Infrastructure NSW's Blackwattle Bay Response to Submissions

I write to you regarding Infrastructure NSW's (INSW) Blackwattle Bay Response to Submissions (RtS) currently open for comment.

To assist the project, the City completed a [Design Review](#) of the proposal which found the Blackwattle Bay proposal needed the following improvements:

Figure 36 Comparison uses between the INSW study and CoS Design review

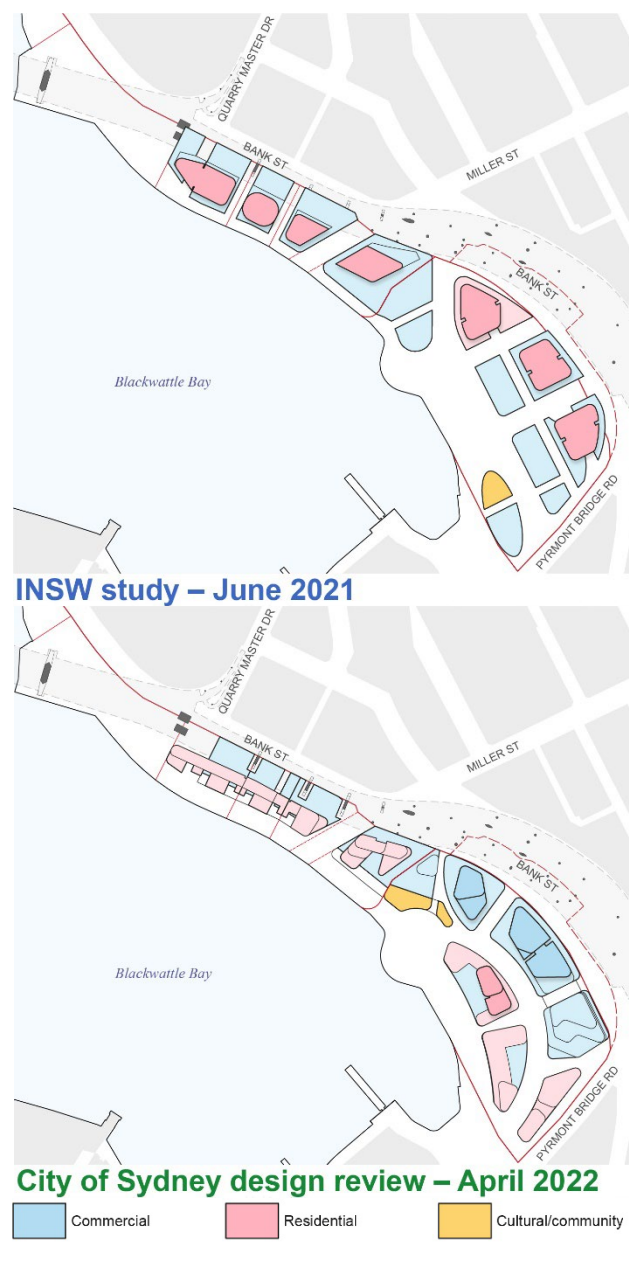
The distribution of uses in the INSW study (refer Figure 36) has shortcomings, including:

- Increased floorspace on the fish market site
- A range of commercial floor plates including larger footprint podiums for commercial uses (refer Figure 37); and,

Figure 39 Comparison of noise exposure between the INSW study and CoS Design review

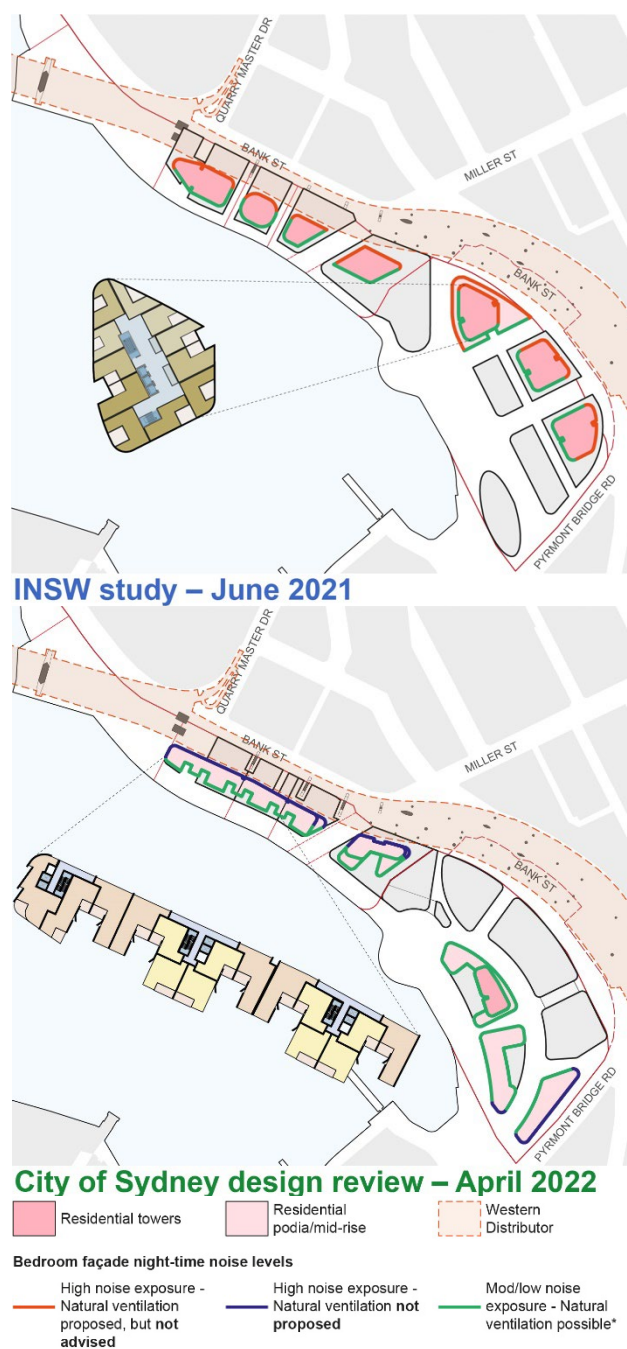
As shown in Figure 39, for the northern sites where apartments are in close proximity to the Western Distributor, the buildings are carefully laid out to meet the ADG with reasonable alternative solutions. This includes orienting private open spaces away from the noise source, and the careful design of apartments to ensure all habitable rooms can be naturally ventilated with windows protected from the noise source. On the north-eastern frontage use of fixed secondary windows in living spaces provide solar access; and corridors and non-habitable rooms are also located here.

Figure 41 Comparison of uses in relation to the Hymix concrete batching plant between the INSW study and CoS Design review

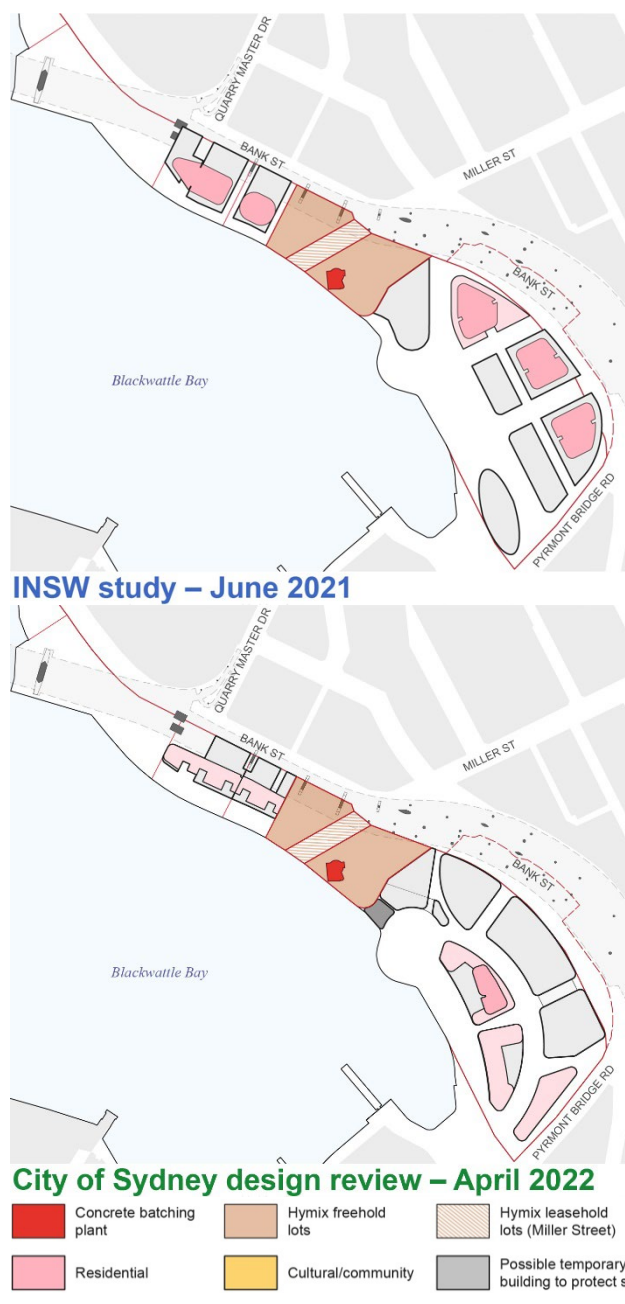
The Design review found that the built form arrangement can be improved to minimise the effects of the concrete batching plant operations. As shown in Figure 41 these include:

- On the Sydney Fish Market site –
 - Residential uses separated from and face away from the Hymix site;
 - A commercial and a cultural building act as a barrier along the Hymix boundary; and,
 - Provision for a possible, and, temporary structure against the Hymix boundary in the foreshore promenade zone, to complete the boundary protection of the site from air and noise pollution.
- For the northern sites that are further from the batching plant, other solutions are found, including:
 - Modulated façades – produces noise shadows within the building recesses reducing noise levels entering residences; and,
 - A party wall on the Hymix boundary – with no windows or openings on this frontage to reduce acoustic and visual impacts.

Figure 49 Views from the sun – showing existing living room windows receiving sunlight, with the INSW study proposal overlaid in grey

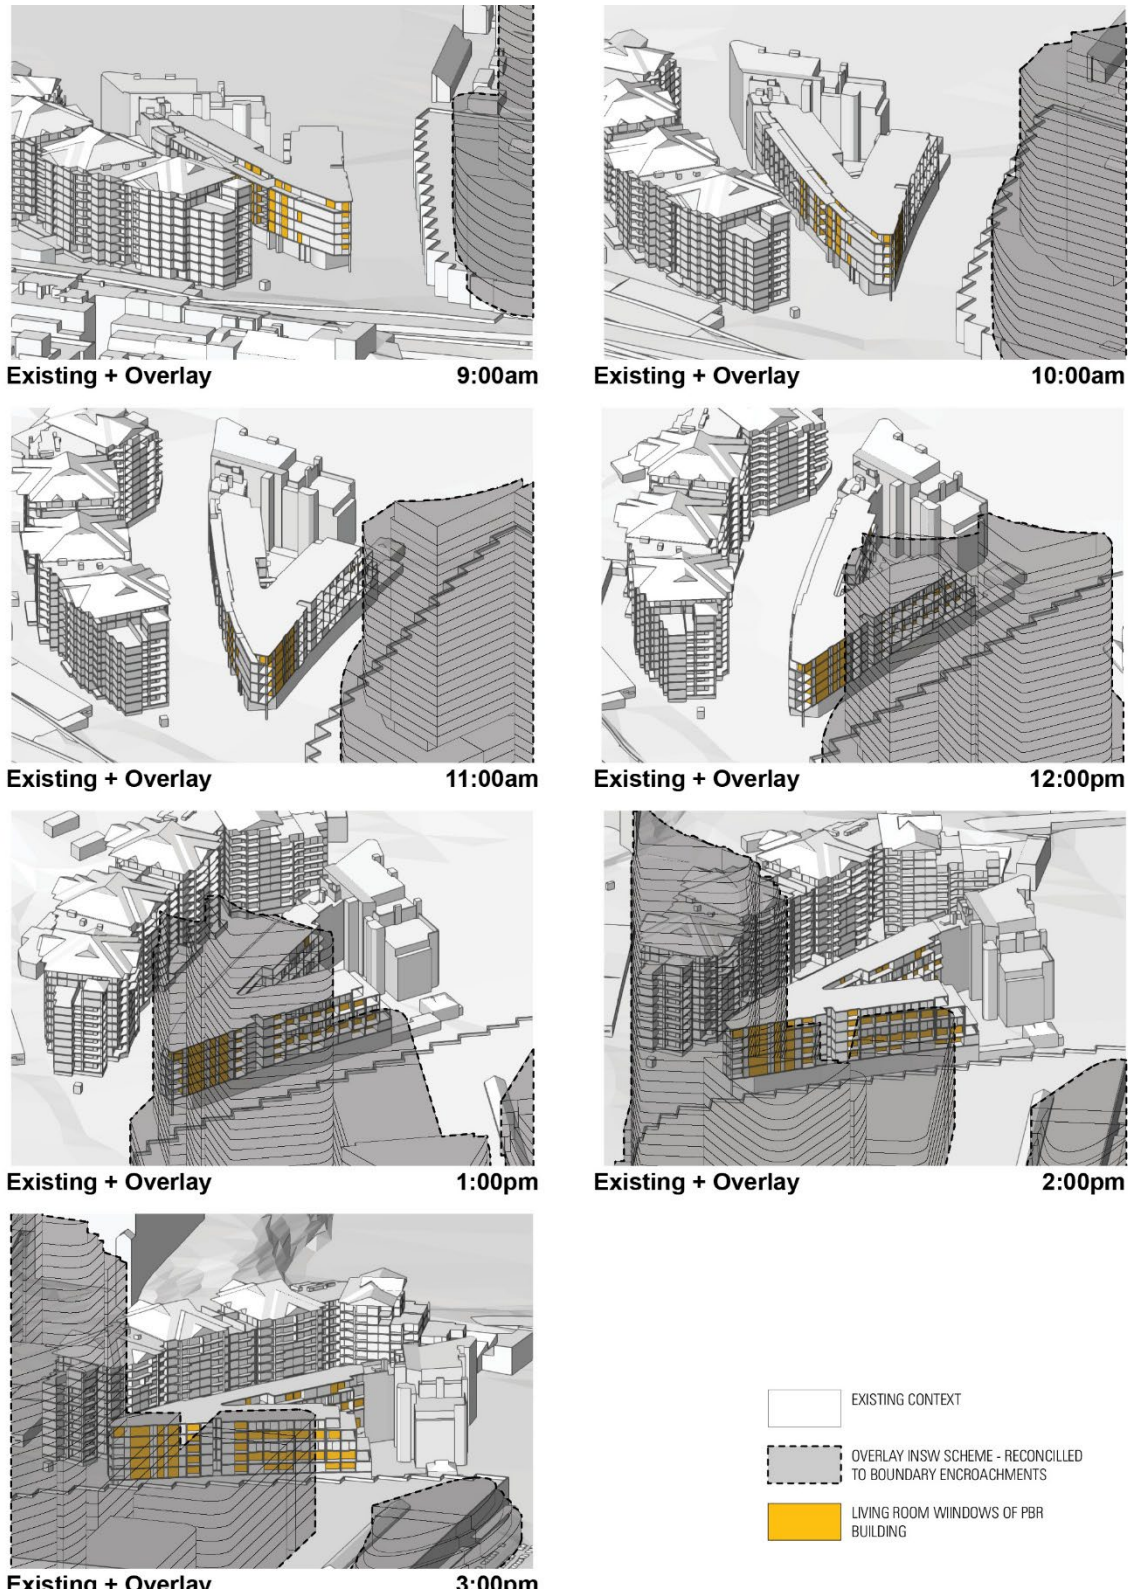
Figure 49 shows the views from the sun for Site 01 at one hour intervals from 9:00 AM through to 3:00 pm on the winter solstice. On each

façade of the building the living room windows receiving sunlight are highlighted yellow, with the INSW study proposal overlaid above in grey.

Figure 51 Sun planes – sun planes required to ensure ADG compliance for solar access to Site 01

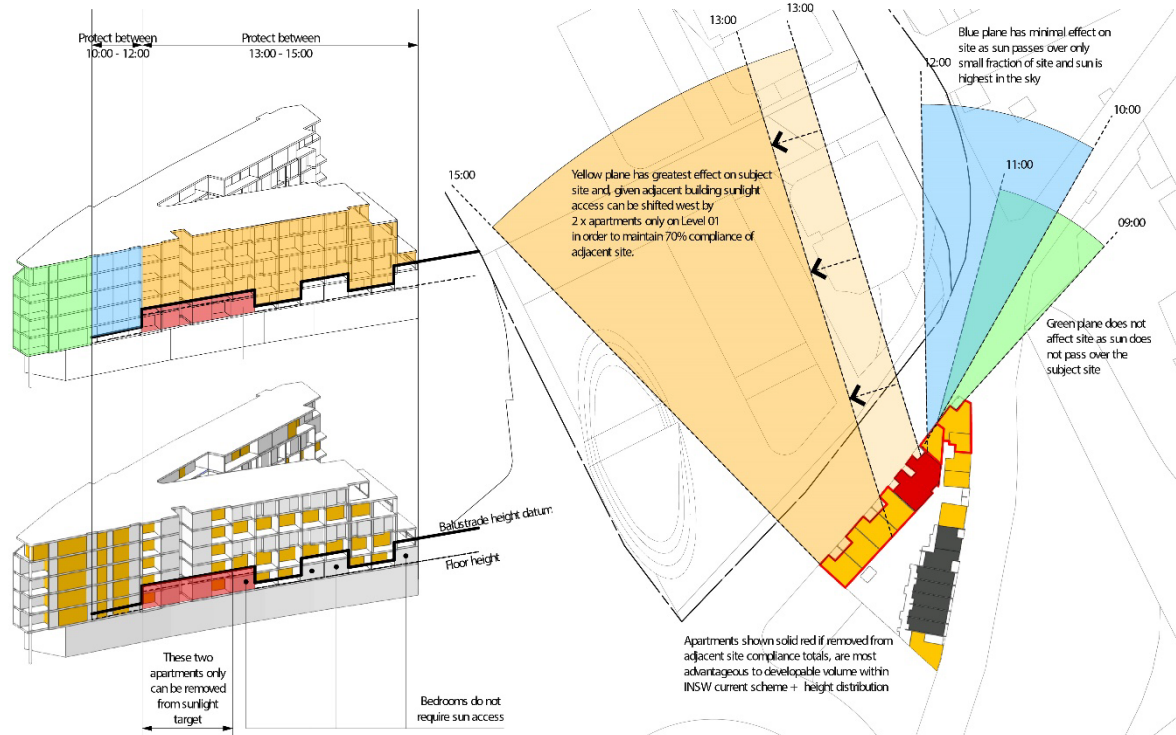
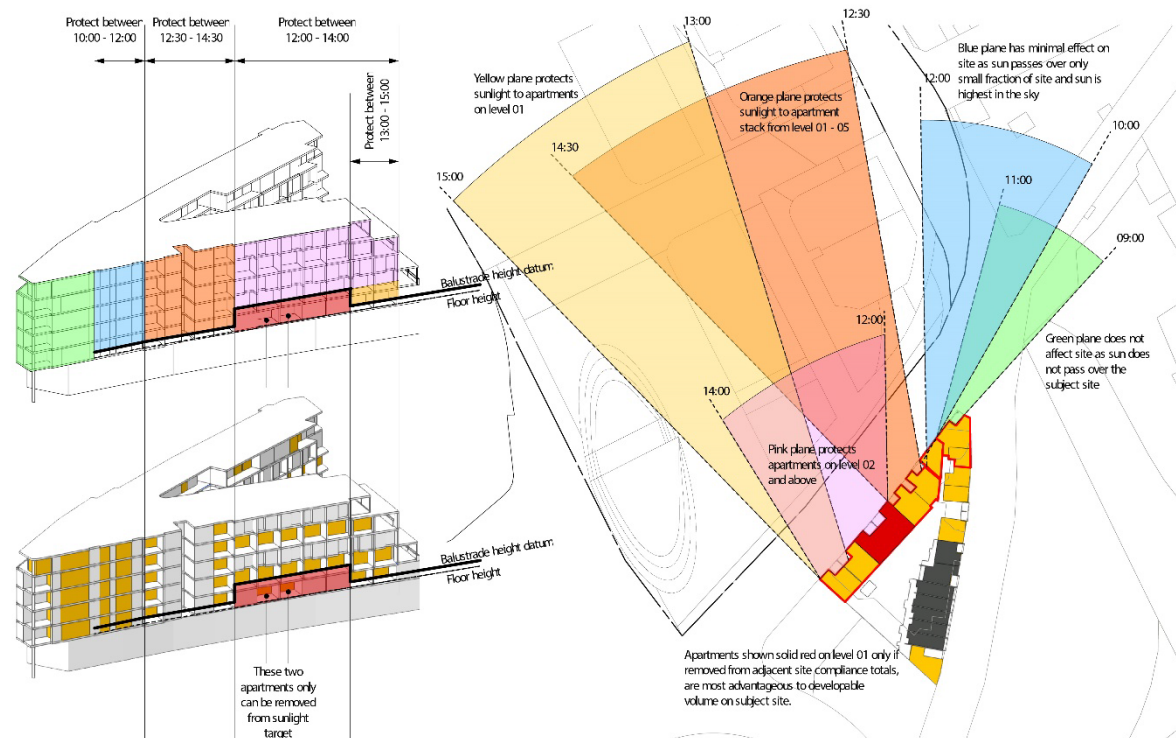
Figure 51 shows the sun planes required to ensure ADG compliance for solar access to 70% of the apartments within Site 01. They demonstrate two options to maintain 70% of apartments receiving the required amount of

sunlight and do not increase the number of apartments receiving no sunlight.

Figure 52 Sun planes Option 01 + Option 02 compared

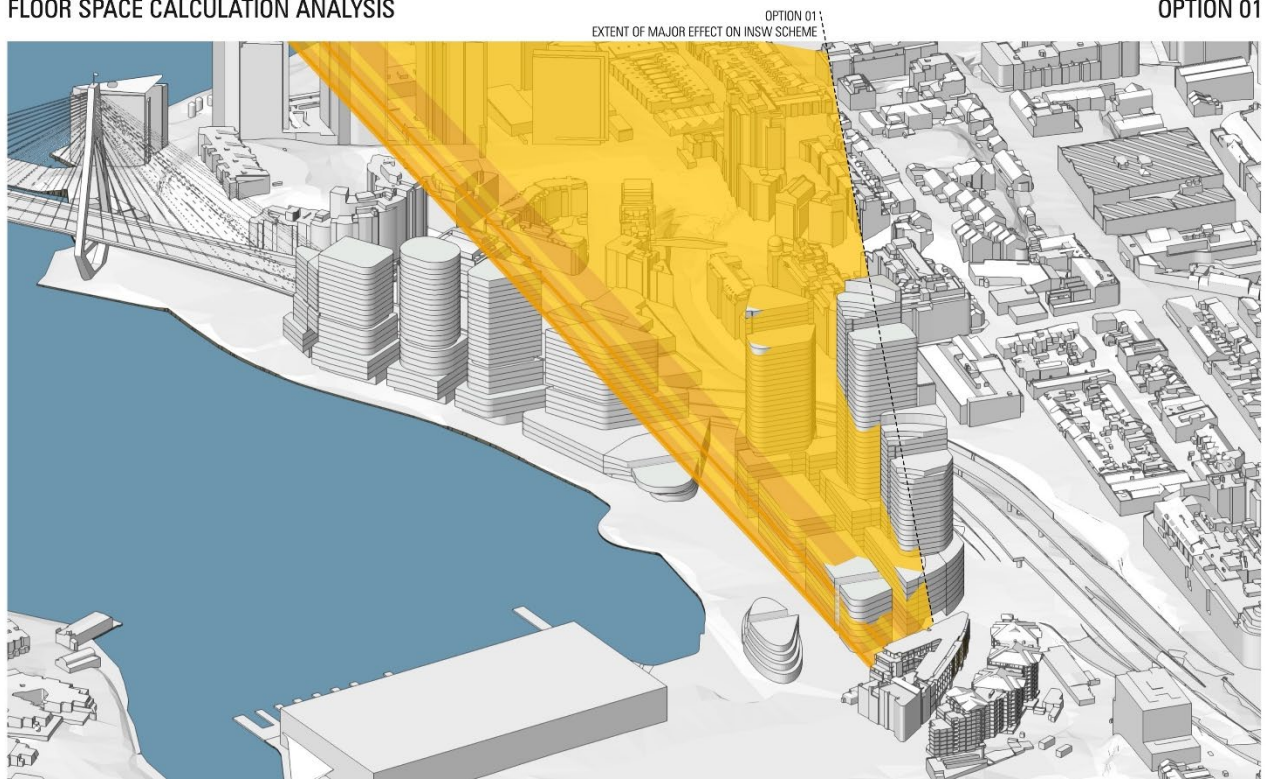
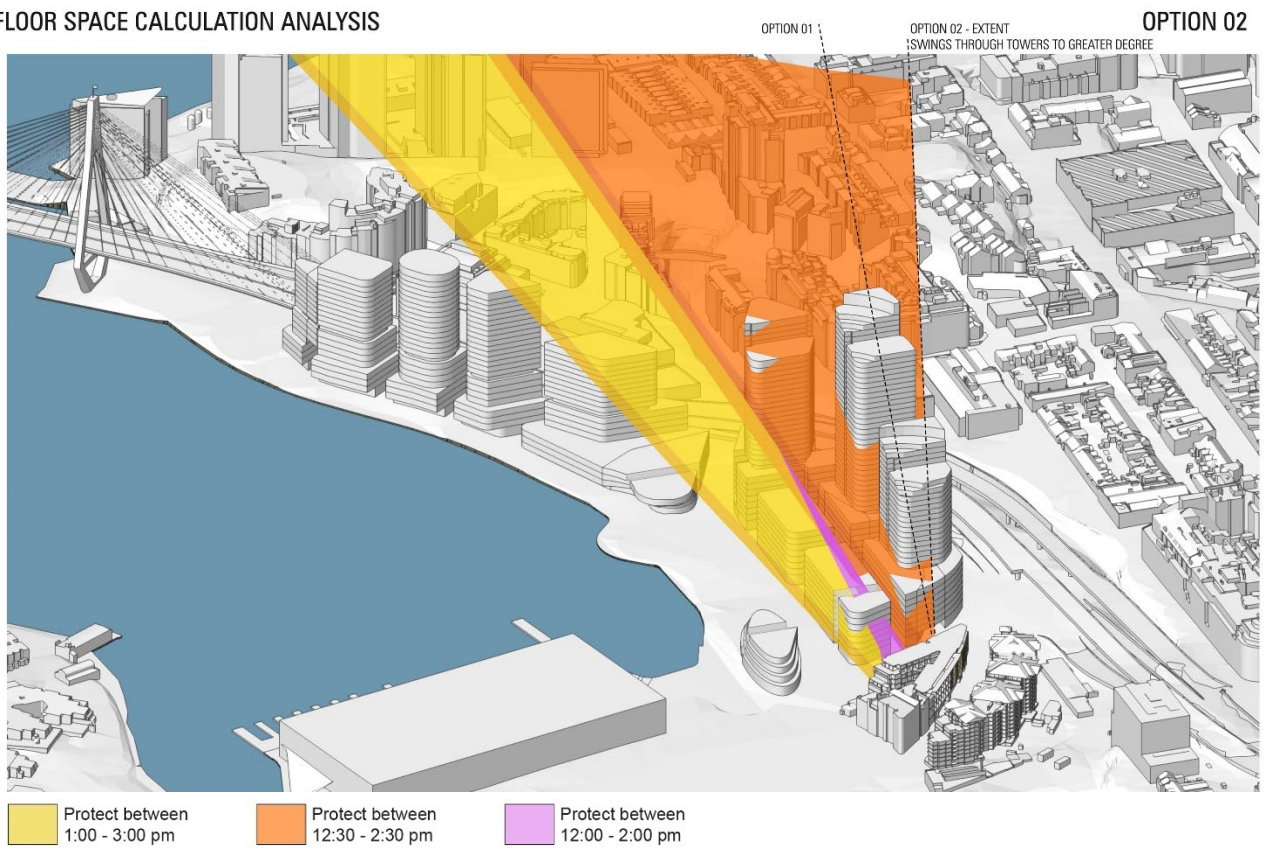
When compared, the two sun plane options have different impacts on the built form in the INSW study, as shown in Figure 52.

Figure 57 Views from the sun – showing existing living room windows receiving sunlight, with the INSW study proposal overlaid in grey

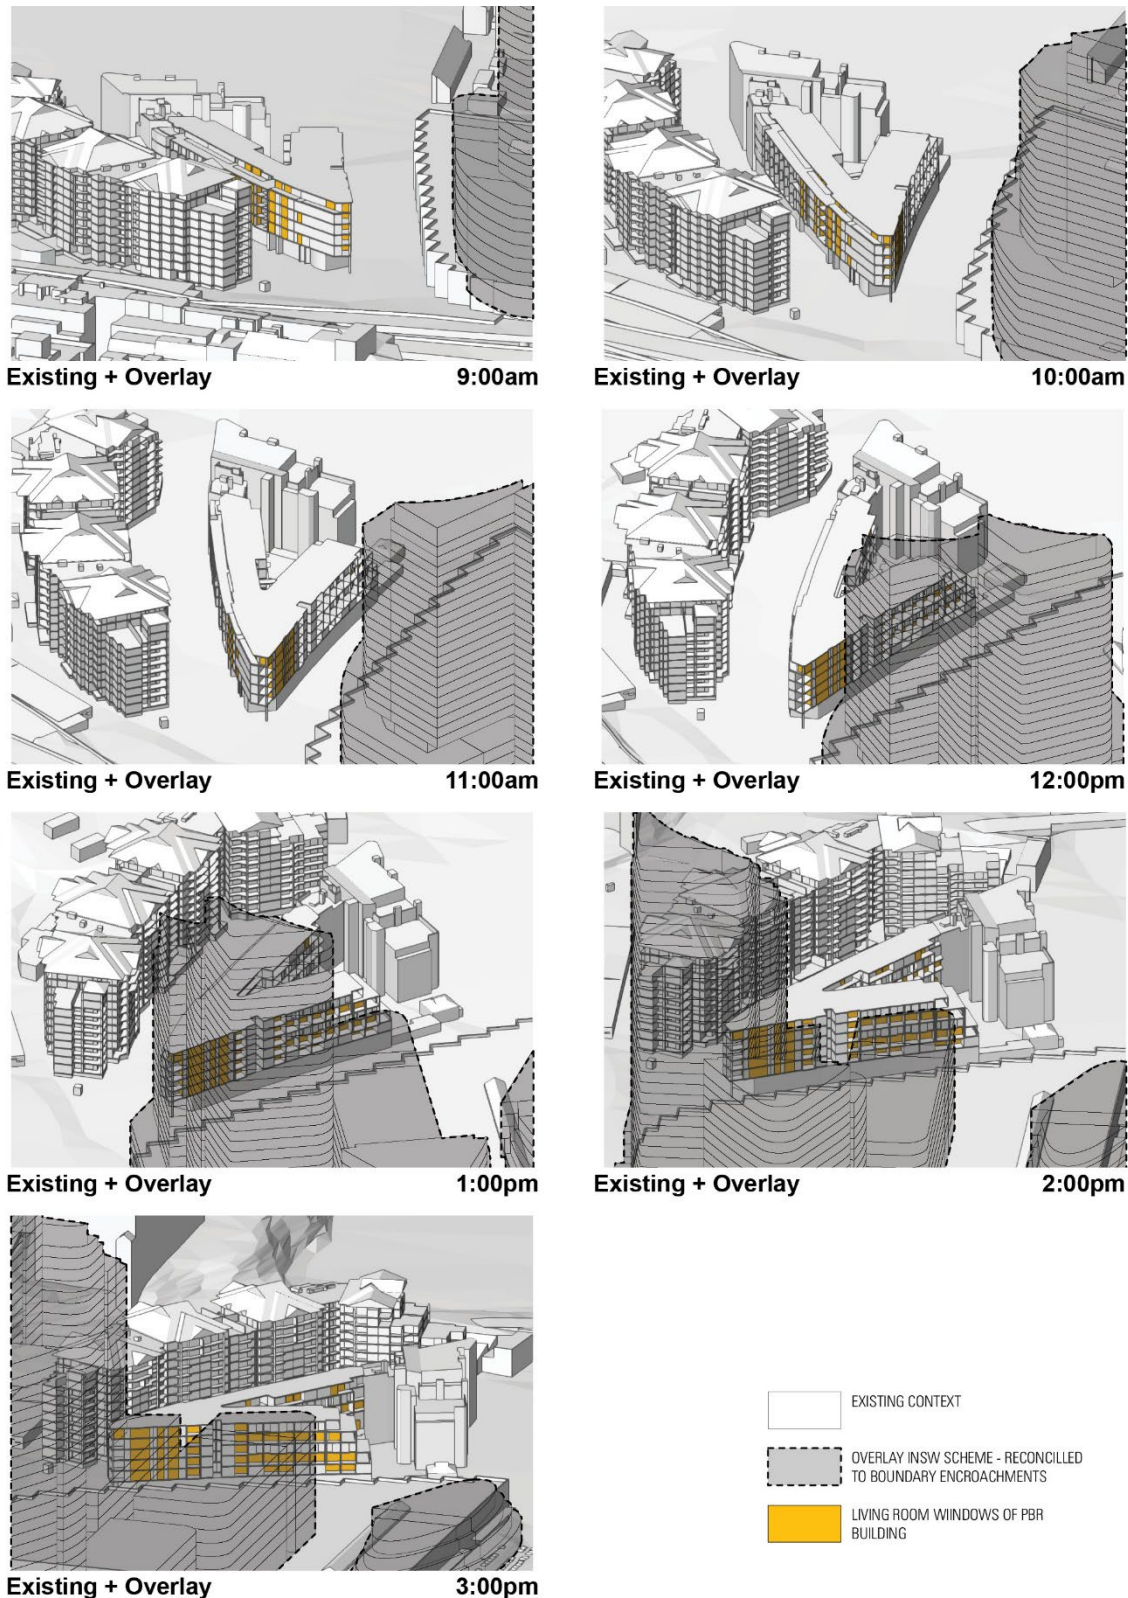
Figure 57 shows the views from the sun for Site 03 at one hour intervals from 9:00 AM to 3:00 PM on the winter solstice.

Figure 59 Sun planes 01 + 02 for Site 03

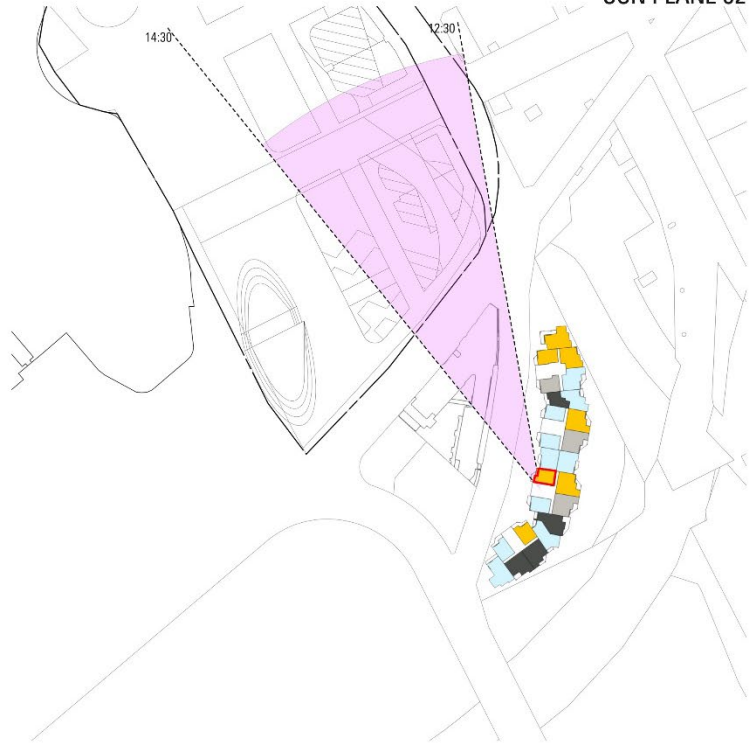
Figure 59 shows an additional sun plane (Sun plane 02) added to ensure overshadowing is minimised to the apartment within Level 01 within Site 03.
